UNITED STATES PATENT AND TRADEMARK OFFICE

10/551,141

Office Action Summary	Application No. 10/551,141	Applicant(s) KARLSSON, DENNIS	
	Examiner Syed A. Islam	Art Unit 3611

DETAILED ACTION

Figure A

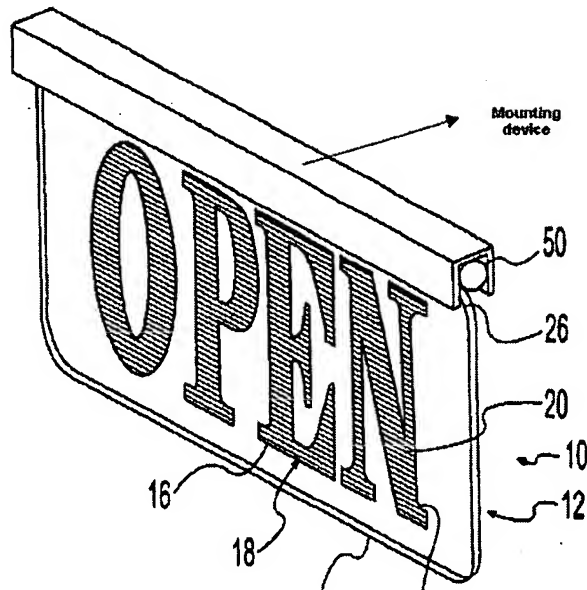
Regarding claim 23, Bradford disclose a first mounting device, that is adapted to position and/or protect light-emitting elements at or inside an edge portion of said electric sign. (see figure A below).

Regarding claim 24, Bradford discloses said mounting device is a continuous element that is arranged along a main part of said edge portion (see figure A where is shows the mounting device is one element).

Regarding claim 27, Bradford as modified discloses said mounting device is provided with at least two connecting means, arranged at different angles in relation to each other. The two side walls of the mounting device can be used as connecting means to connect with a wall or other connectors (see figure A above).

Regarding claim 28, Bradford discloses said mounting device is provided with at least two connecting means displaced by 90° (see figure A above).
